FINAL
YEAR 4 (2019) ANNUAL
MONITORING REPORT

**NEIGHBORS BRANCH/WALTON CRAWLEY BRANCH
STREAM & WETLAND RESTORATION SITE**

NCDMS Project No. 92872
Contract No. D09023S
USACE Action ID No. SAW-2009-917 & NCDWR Project No. 10-0122
SCO No. 08-07308-01
McDowell County, North Carolina

RE: Neighbors Branch/ Walton Crawley Branch Monitoring (DMS Project # 92879, Contract # D09023S)
Final Year 4 (2019) Annual Monitoring Report

**FIGURE
 2B**

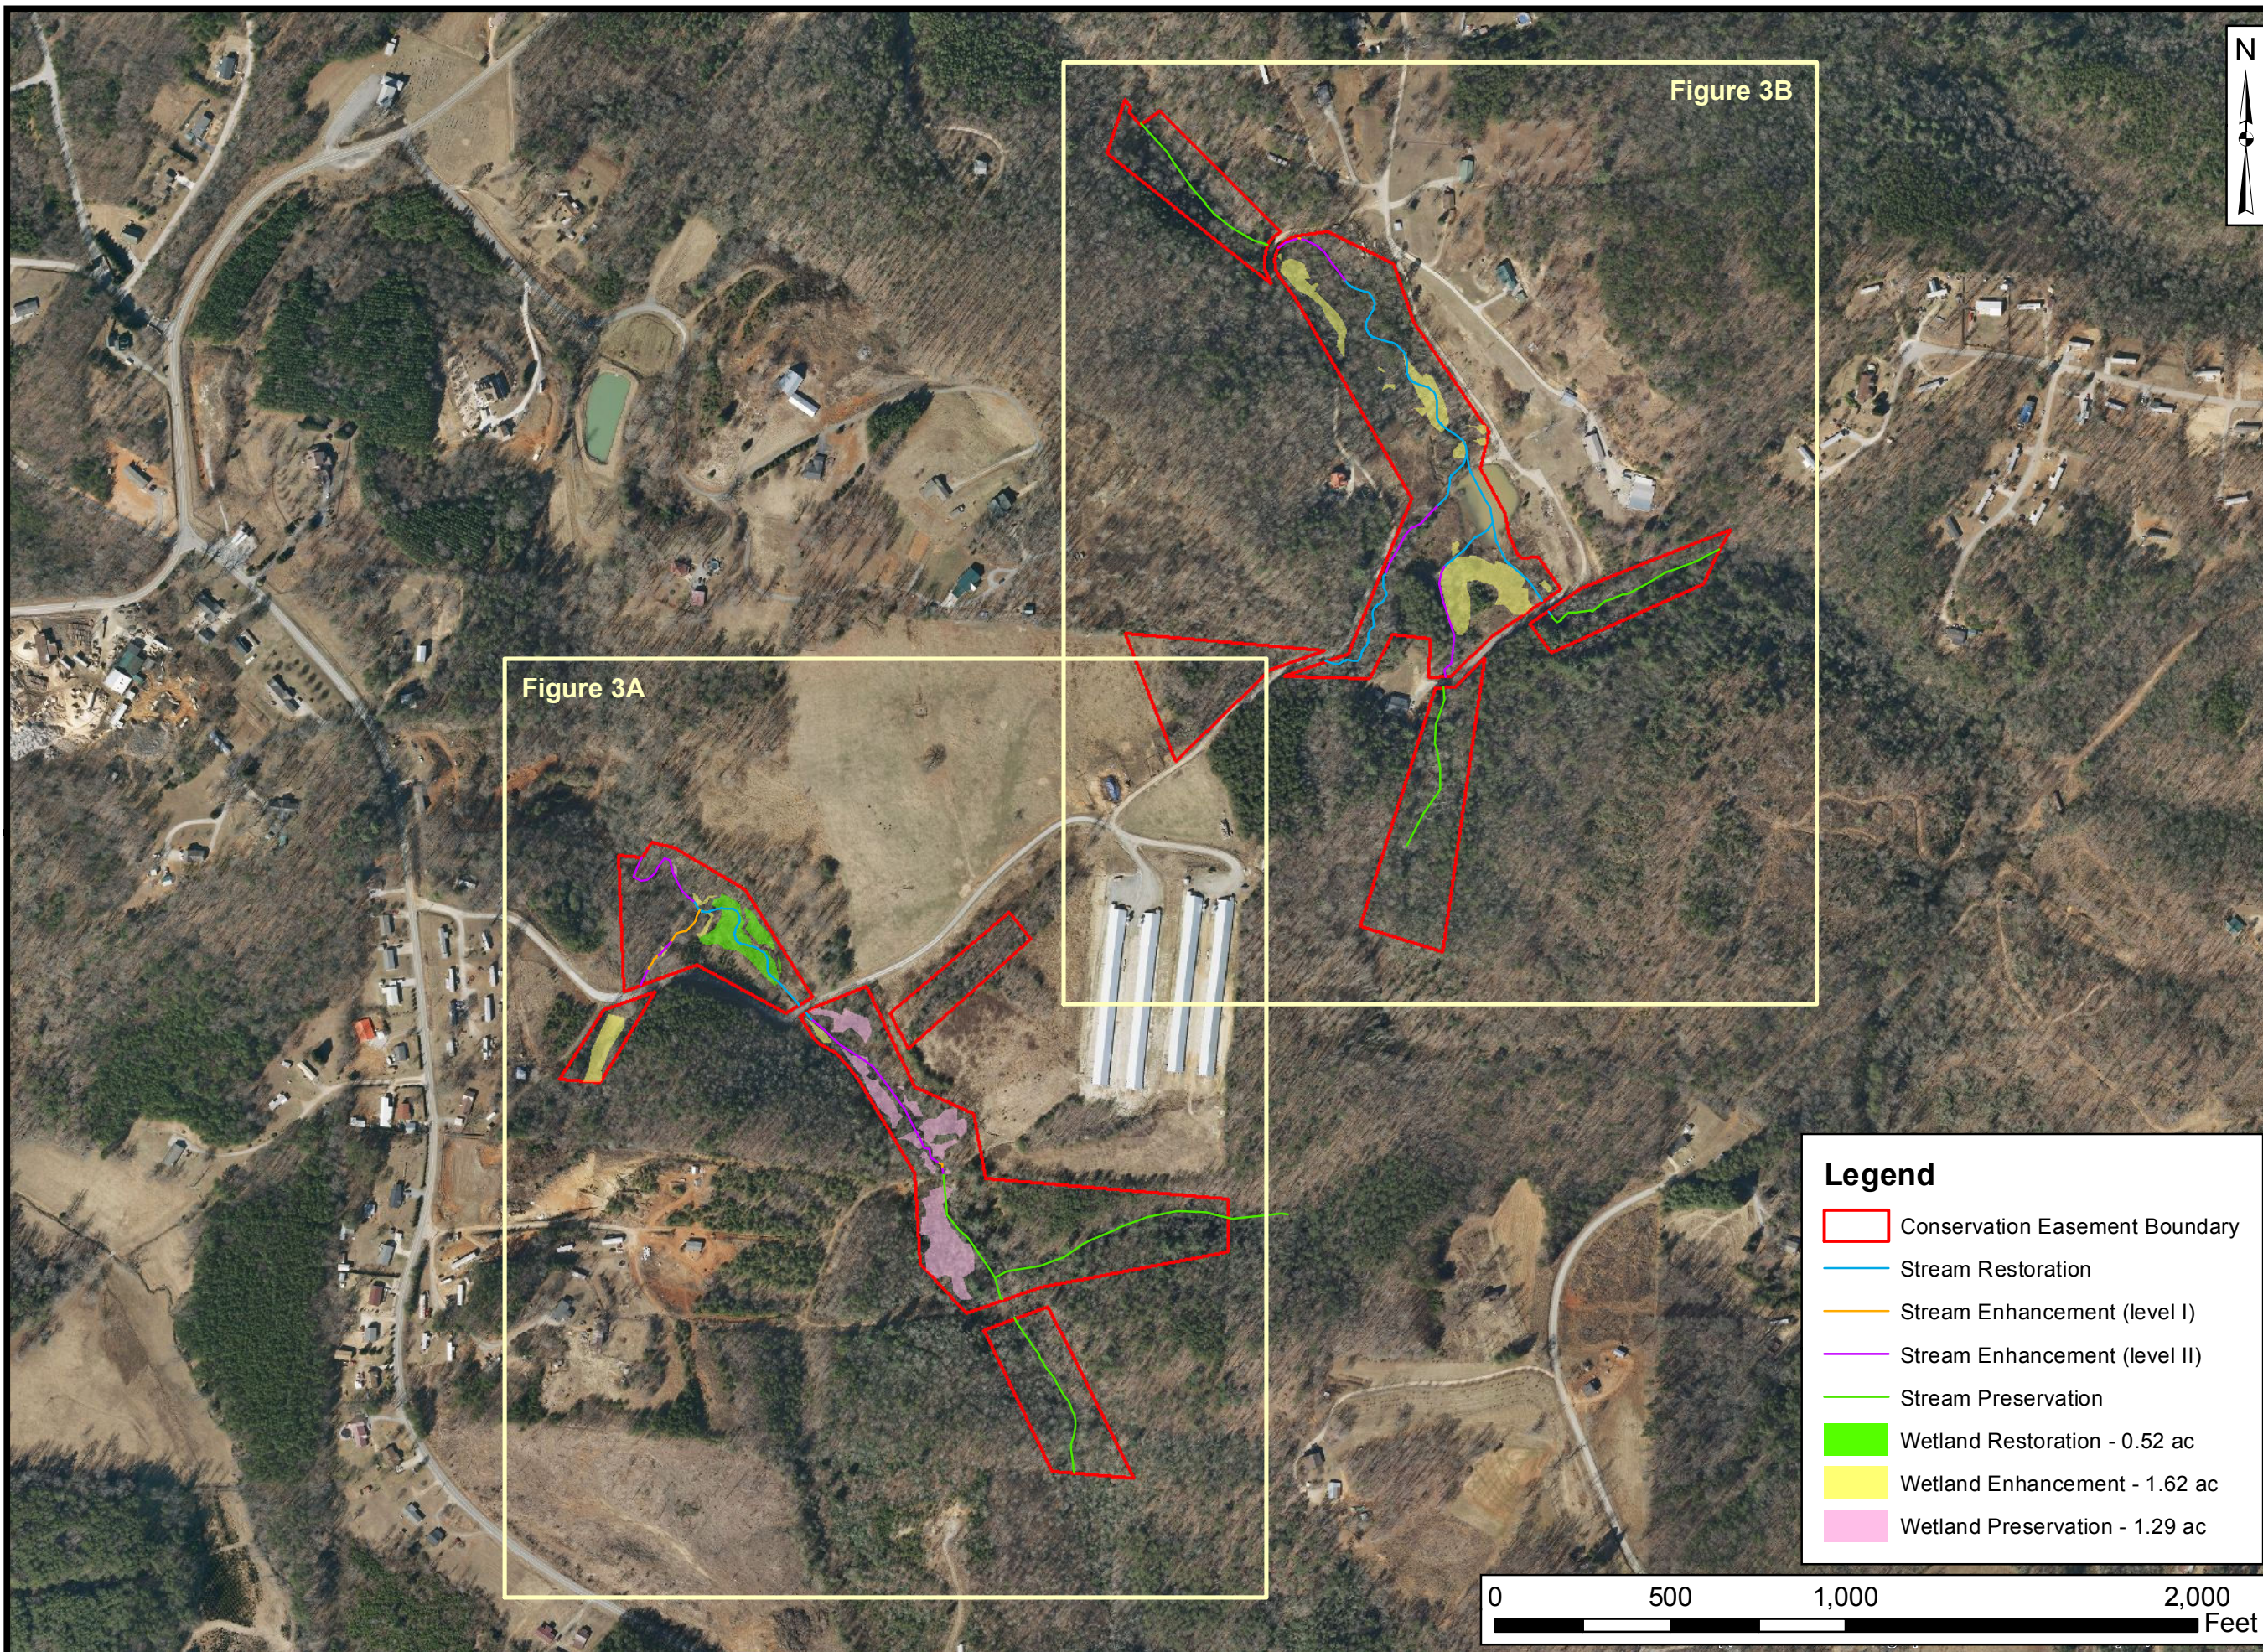
These items were added to table 2.
- CCPV: Please remove dense shrubby bushclover from CCPV. This species has not been high priority species in the past with the regulatory agencies. Please update Table 6 to exclude bushclover as well.

Shrubby bushclover occurrences were removed from the CCPV and table 6.
- CCPV: Please add the locations of debris removal and repaired structures to CCPV and add a callout (see attached map).

Callouts were added to highlight the locations of debris removal and repaired structures.
- Cross sections: The summary data on some of the cross sections does not match the Table 11 data. I think MY3 data may be showing on the graphs. Please verify and correct as necessary for all occurrences. Digital deliverable comment is referring to this as well.

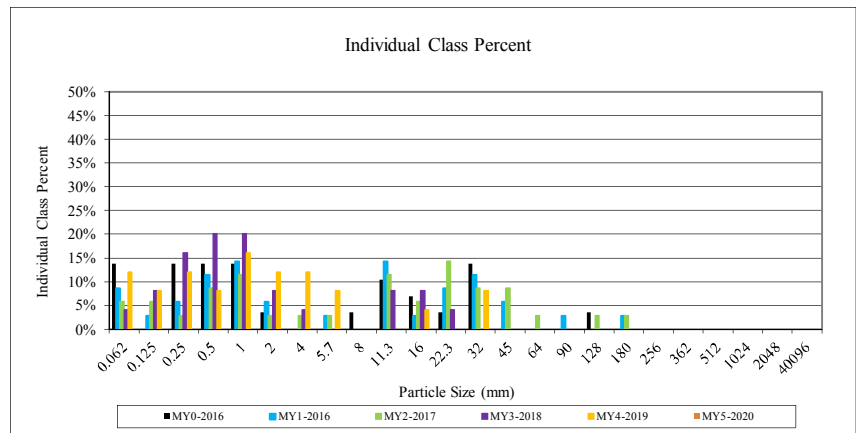
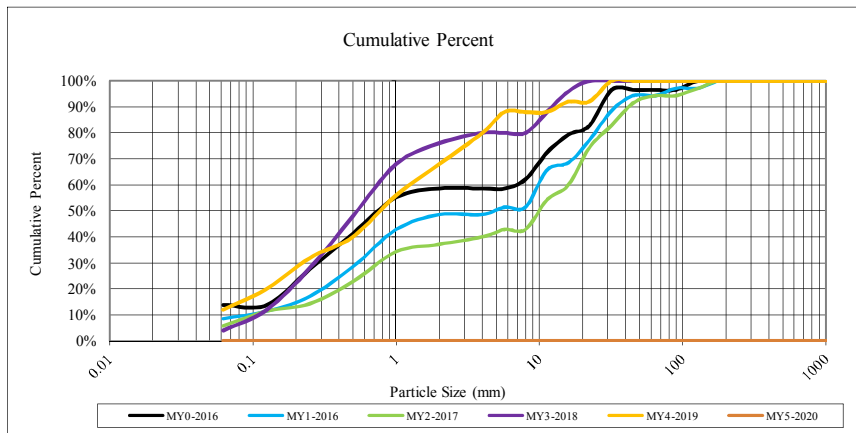
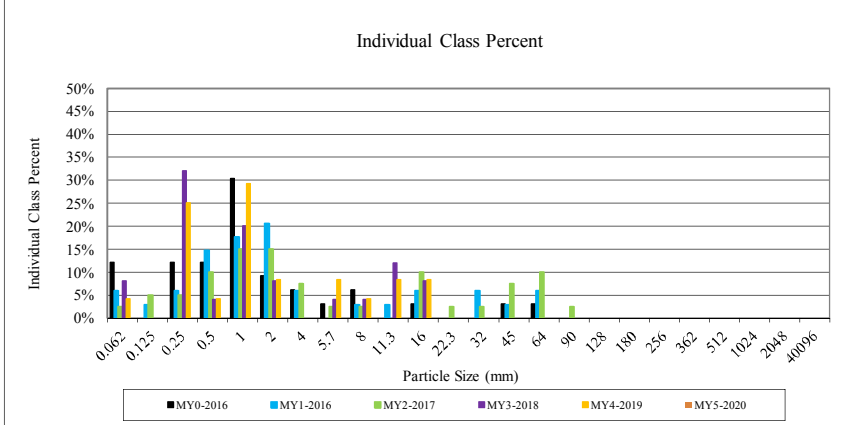
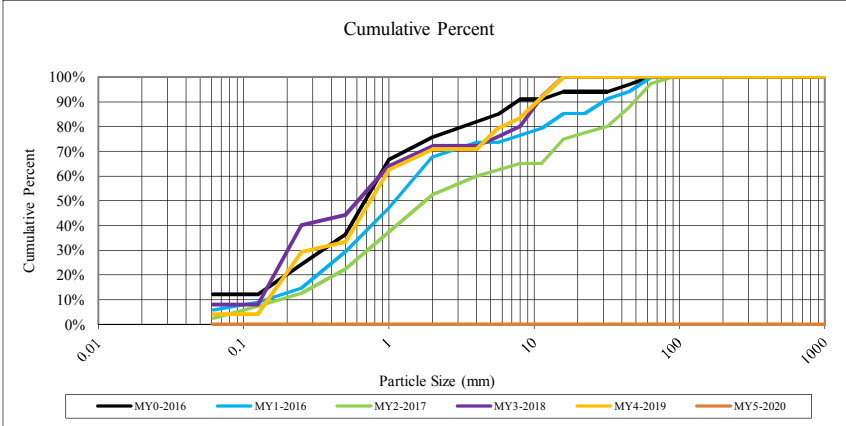
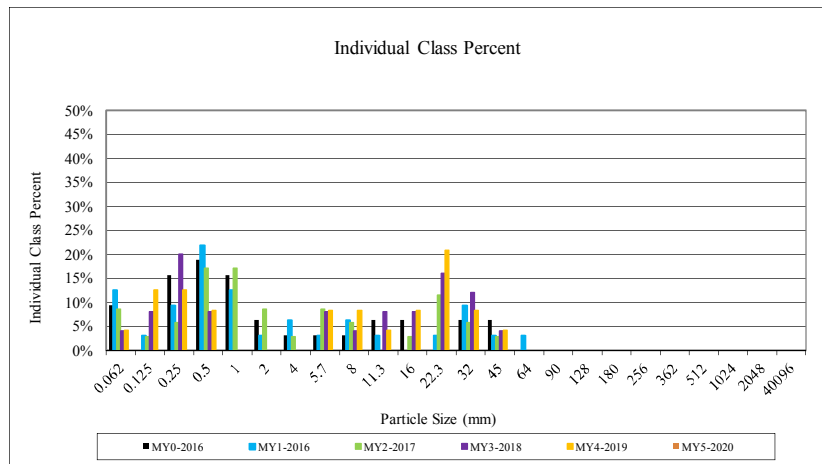
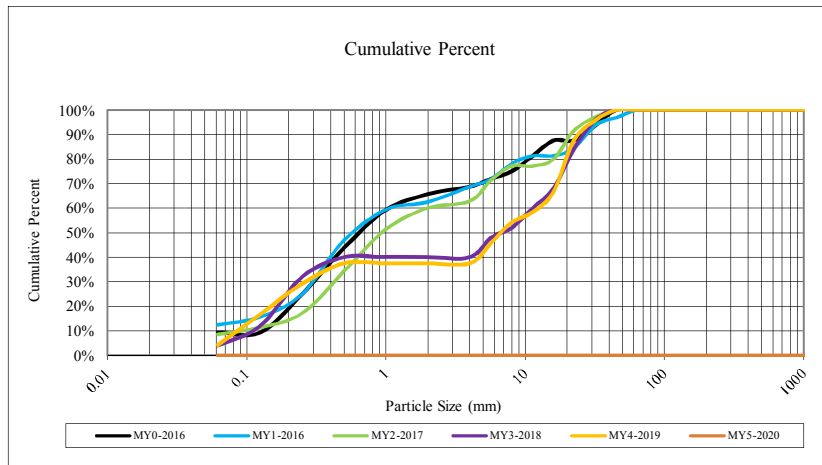
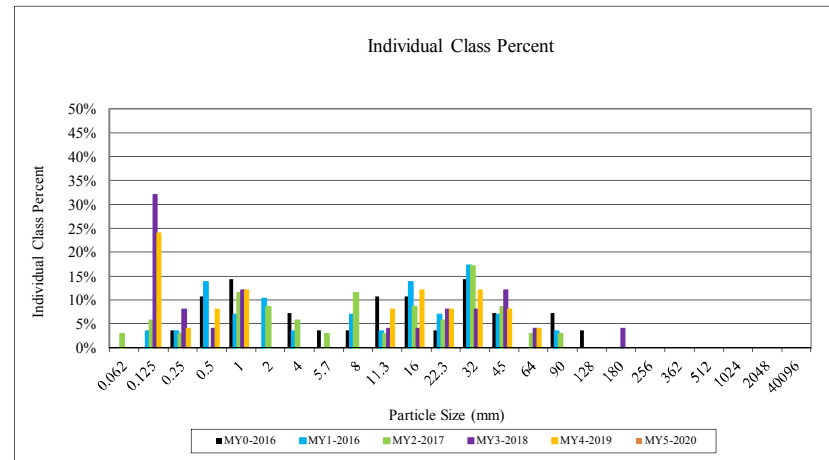
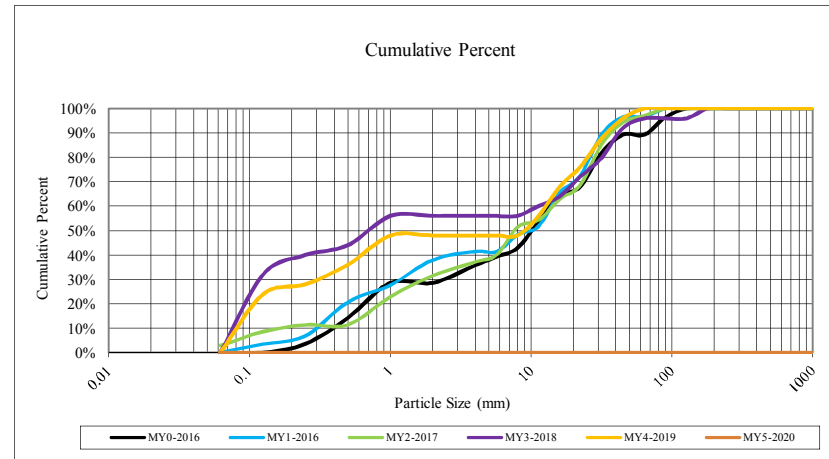
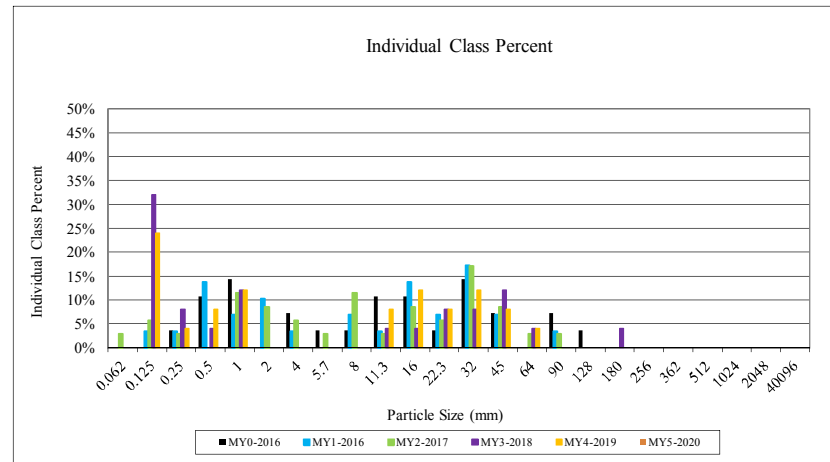
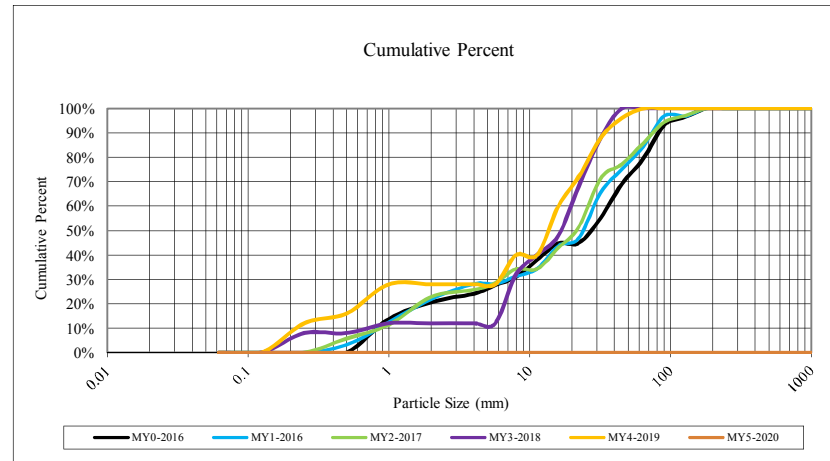
The "Stream_Assets.shp" shapefile has been updated to match the asset table.
- Cross section figures display values in summary data tables that are not representative of MY4 data, as indicated by table 11. There are also references in the provided cross section excel sheet between low top of bank and bankfull depth, and these values may be equal, but they should be separately identified to prevent future errors if they deviate. Although it is indicated in table 11 that the new methodology for calculating bank height ratio was used, this cannot be verified without a clear indication of the low top of bank and bankfull elevations used. Please consider identifying these data, or using the DMS template for cross section calculations.

Cross-section graphs have been updated to reflect year 4 data.
- Stream spatial features in the DMS geodatabase do not match reported values in asset table and the stream asset features provided in the CCPV folder were not segmented or clearly defined as they are reported in the asset table. Please provide features that characterize the creditable assets that have been reported, ensuring that features are segmented and attributed as they are in the asset table and that feature lengths match the linear feet reported. All wetland feature areas match creditable acreage.

Cross-section graphs have been updated to reflect year 4 data. Bankfull elevation and LTOB elevations have been identified on the cross-section graphs as well.
- Please provide DMS with the wetland hydrology and precipitation data that were used to create groundwater gage figures.
